INVITATION FOR BIDS No: CS-2020-0027

**City of Globe**  
**Walliman Road Waterline Replacement**  
**Project**

Addendum #2  
Dated: 08/19/2020

**Revised Bid Schedule and Revised Plans dated 08-18-20.**

Water Trench Detail

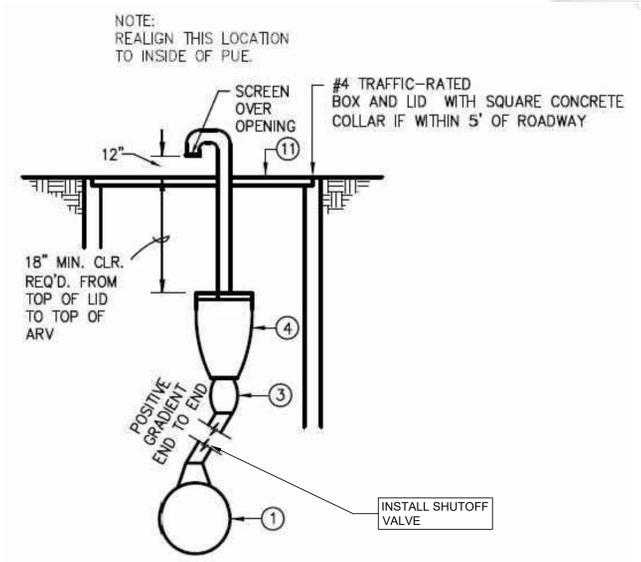
- Traffic Control: Road closures are acceptable if local traffic is maintained
- Sewer Crossing: Per ADEQ, sewer services do not have a separation requirement. There are no sewer main crossings.
- Sand bedding is required 6" above the pipe, compaction is required
- Assume all services from the main will be tied in with new copper to the meter
- Revised plans 8-18-20 attached
